CITY OF ALBUQUERQUE

RE: Loma Vista II

Conceptual Grading & Drainage Plans Engineer's Stamp Date: No Stamp Date

Hydrology File: L08D008

C-100

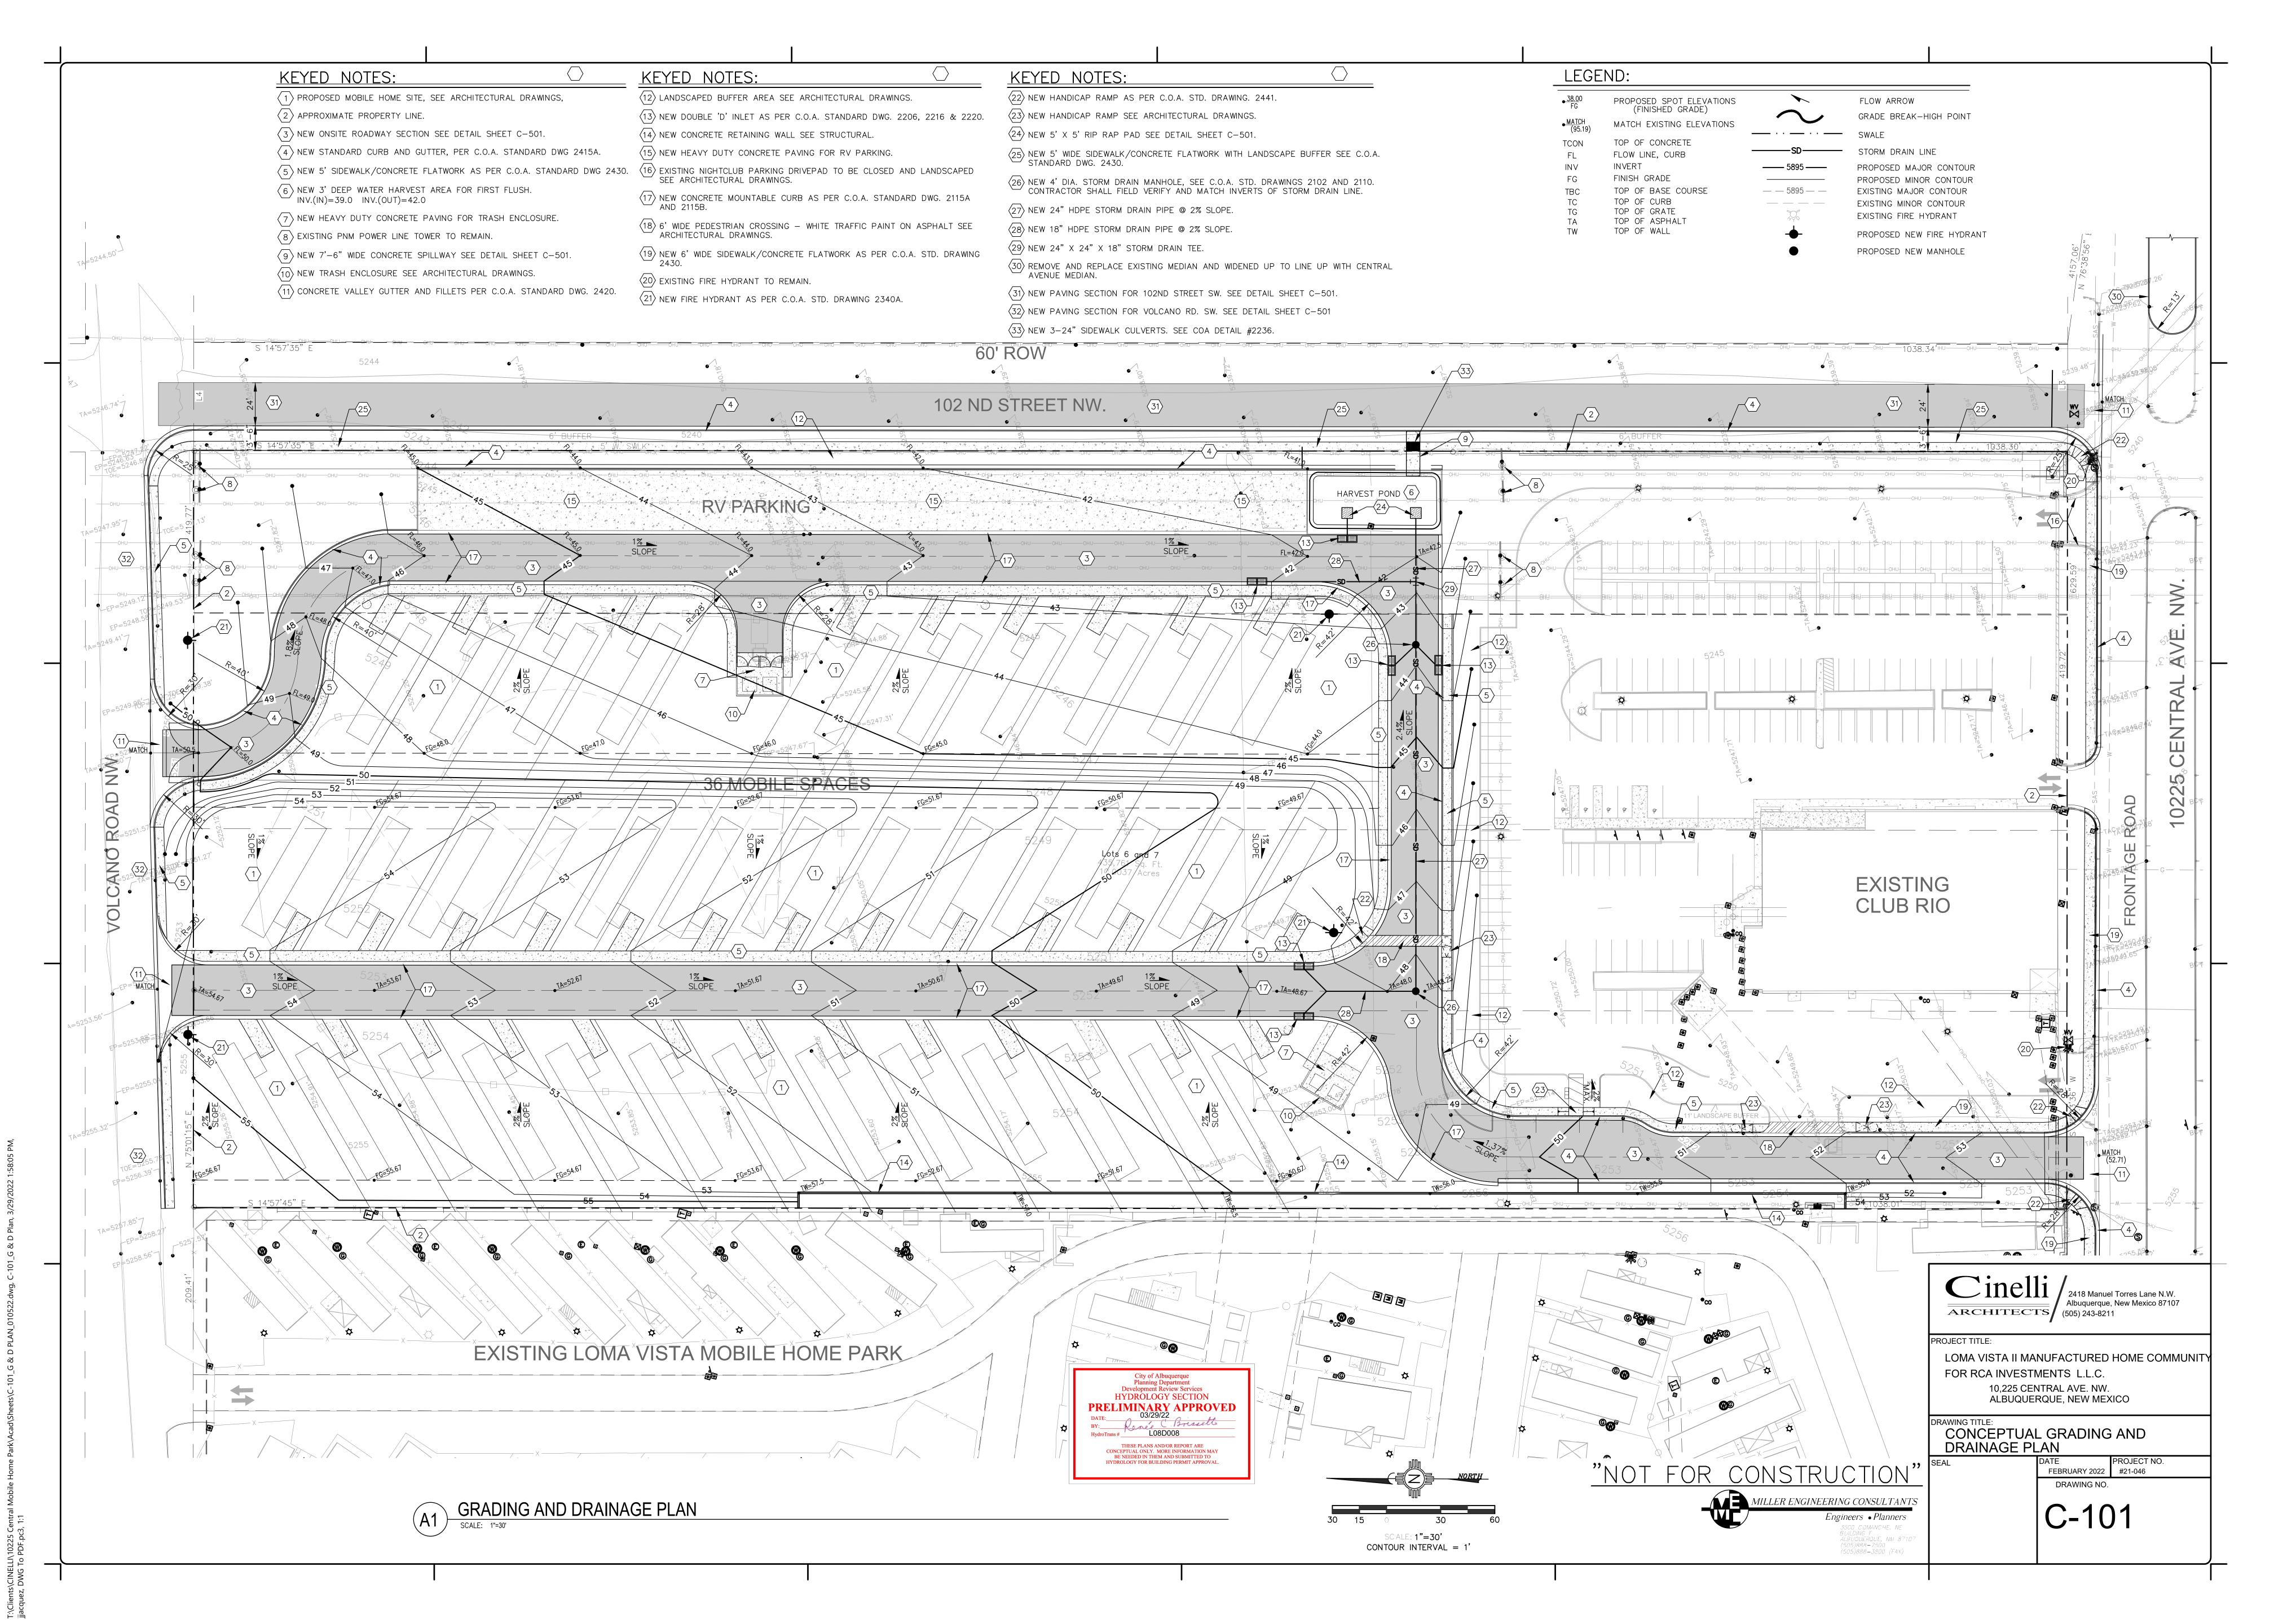
PRELIMINARY APPROVED

THESE PLANS AND/OR REPORT ARE
CONCEPTUAL ONLY. MORE INFORMATION MAY
BE NEEDED IN THEM AND SUBMITTED TO
HYDROLOGY FOR BUILDING PERMIT APPROVAL.
